Access Compliance Report

Public Rights-of-Way

Intersection ID: 15737	Main Street: HUNTLEY_PL	Cross Street: PROVIDENCE_RD	Location: SE
ADA ID: 77EC43B7862C	Ramp Type: PerpDiag	Initial Pass/Fail: Fail	Overall Compliance: No
Severity Score: 8.75			
Codes/Mitigation Info/Possible Solution		Field Measurements/Component Compliance

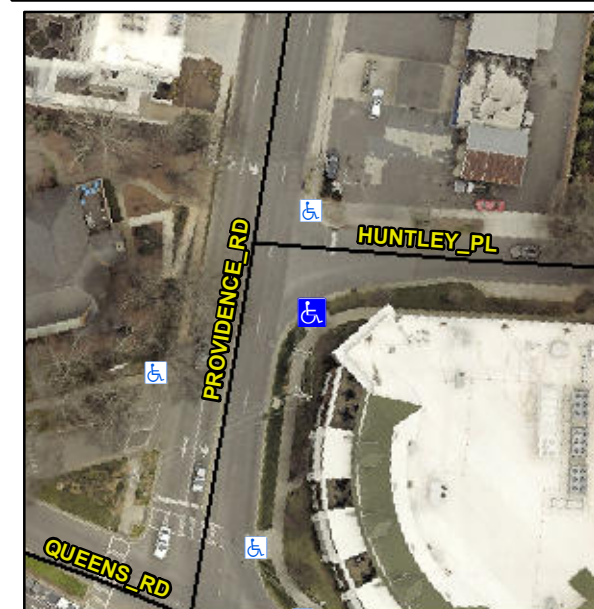
Not Found, R304.5.1

Compliance	Description	Data	Compliance	Description	Data
N/A	Ramp Length (in)	95.0	Yes	Ramp Slope (%)	6.2
No	Ramp Width (in)	47.0	Yes	Ramp XSlope (%)	0.4
N/A	Flare Type LT	N/A	N/A	Flare Type RT	N/A
N/A	Flare Slope LT (%)	N/A	N/A	Flare Slope RT (%)	N/A
N/A	Flare Traversable LT?	N/A	N/A	Flare Traversable RT?	N/A
N/A	Landing Length (in)	N/A	N/A	DWS Provided?	N/A
N/A	Landing Width (in)	N/A	N/A	DWS Contrast?	N/A
N/A	Landing Slope (%)	N/A	N/A	DWS Length (in)	N/A
N/A	Landing X Slope (%)	N/A	N/A	DWS Full Width?	N/A
N/A	Landing Curb? (Y/N)	N/A	N/A	DWS Offset (in)	N/A
N/A	Shared Landing?	N/A			
N/A	Gutter Ponding?	N/A	N/A	Gutter Slope (%)	N/A
N/A	Gutter Lip Ht (in)	N/A	N/A	Gutter X Slope (%)	N/A
N/A	Painted X Walk1?	No	N/A	Painted X Walk2?	No
	X Walk 1 Direction	To NE		X Walk 2 Direction	To NW
N/A	X Walk 1 Width (in)	N/A	N/A	X Walk 2 Width (in)	N/A
	X Walk 1 Slope (%)	2.3		X Walk 2 Slope (%)	1.0
	X Walk 1 X Slope (%)	0.5		X Walk 2 X Slope (%)	0.5

Remove & Replace Curb Ramp With Two New Directional Ramps or Equivalent.
